TENDER

Project  
HEATH HOUSE, HAMPSTEAD, NW3 7ET

Drawing  
G11 - DINING HALL - PROPOSED PLAN & ELEVATIONS

Drawing No.  
HH-345 T2

G11 - DINING HALL PLAN

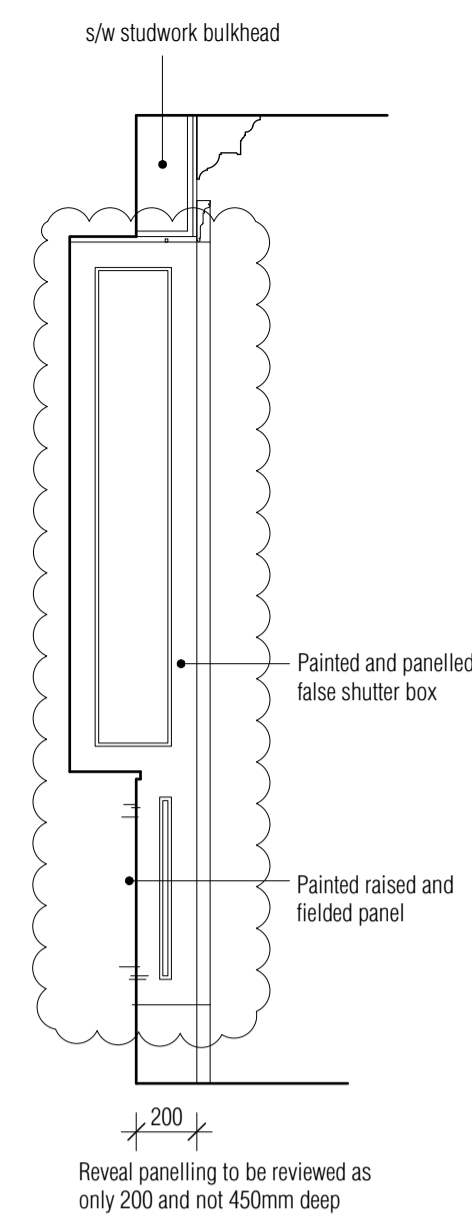
Reveal panelling to be reviewed as only 200 and not 450mm deep
